**ADDENDUM #1**

**RFB #24-0011**

**ADDITIONS AND ALTERATIONS – HOUSEHOLD HAZARDOUS WASTE**

**Addendum Number One**  
To The Drawings and Specifications for  
**Household Hazardous Waste Facility**  
**Bid # 24-0011, Sedgwick County, Kansas**

SHEET  
**A5.6**  
 OF SHEETS

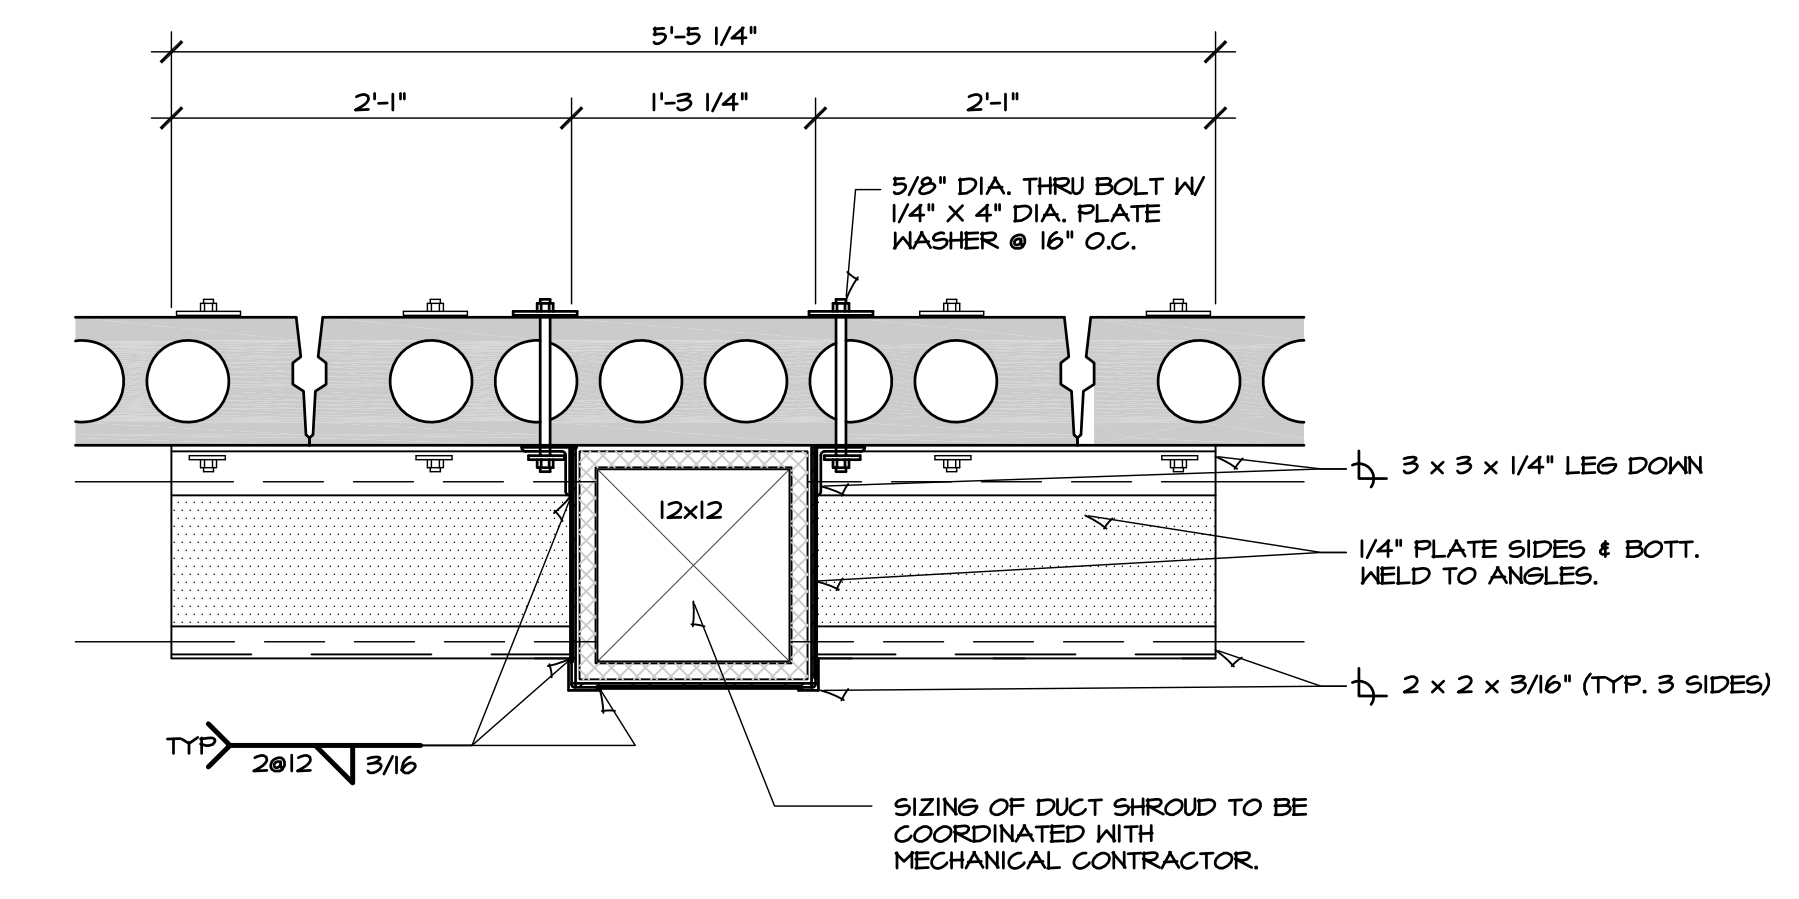
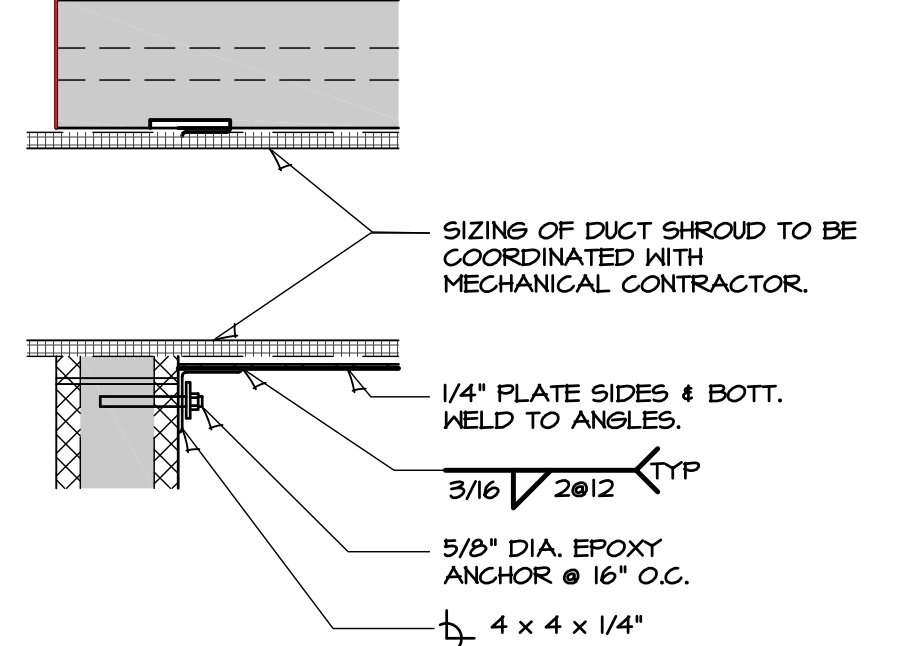
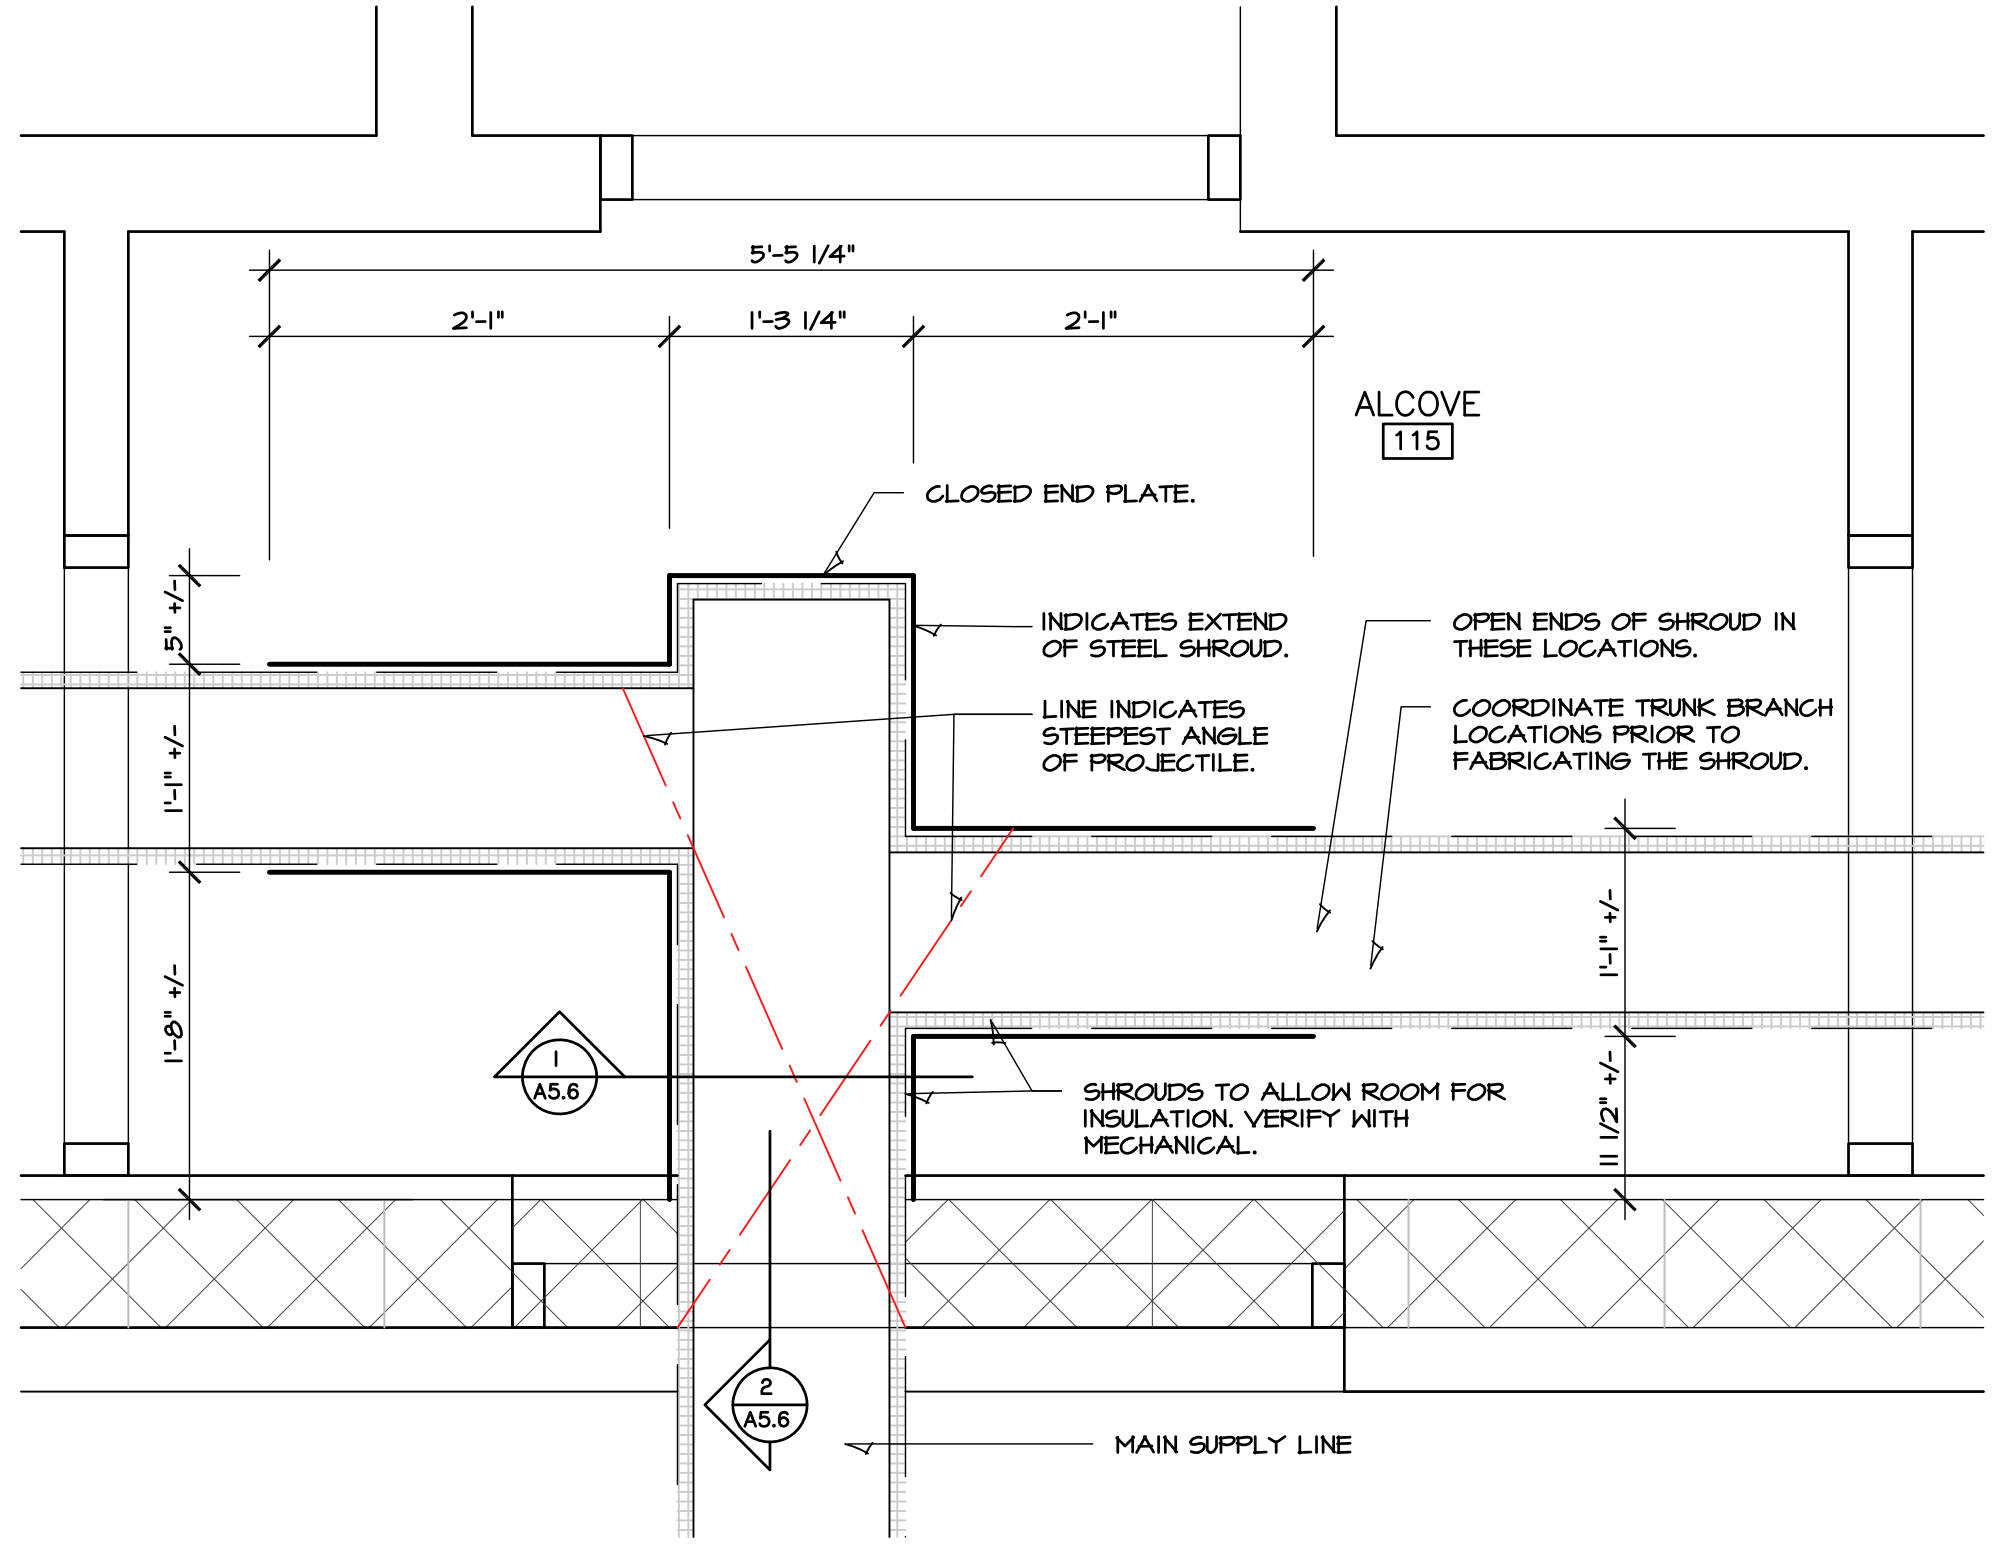
- 3.14 Sheet A5.4
- This sheet has been revised to clarify details of the HVAC duct coming into the hardened storm shelter.
- 3.15 Sheet A5.6
- This sheet has been revised to show details of steel ductwork wrap for the shelter.
